FST WITH SWITCH

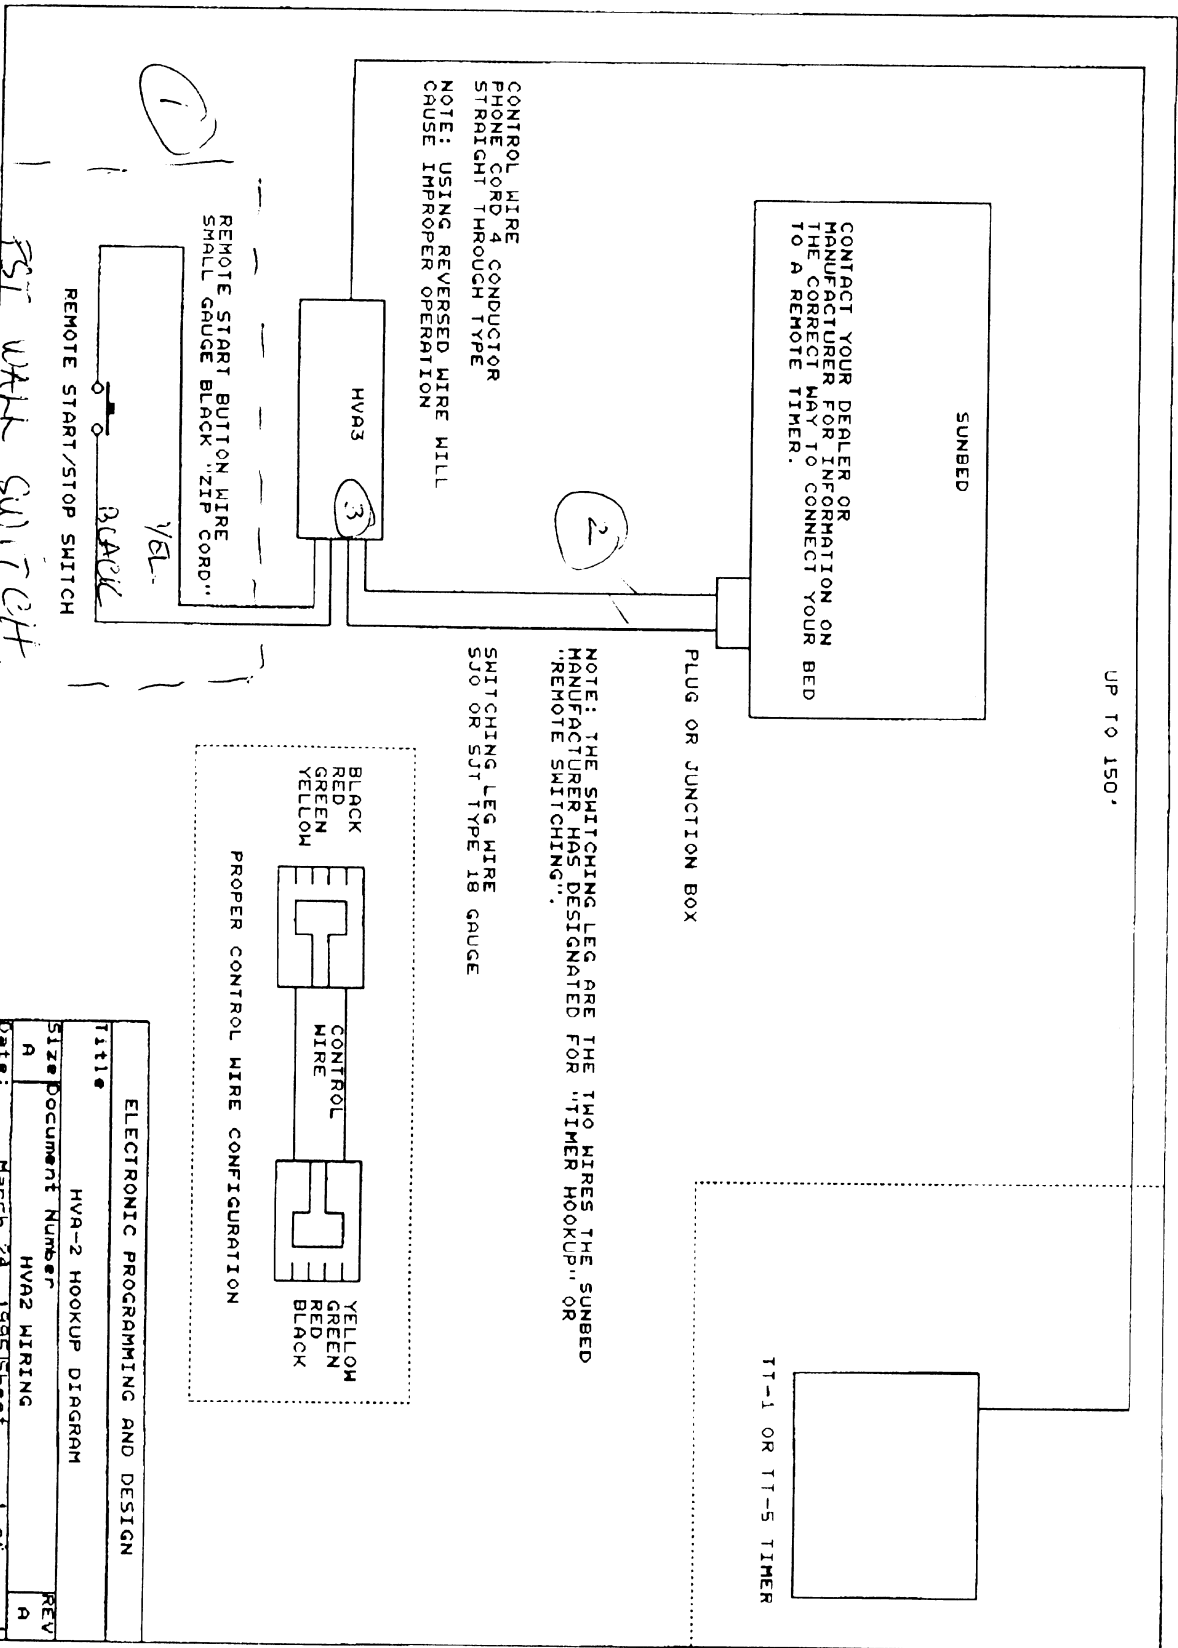
REMOVES WIRES FROM A SCREW TERMINAL ON FST WITH SWITCH AND CONNECT TO (3)
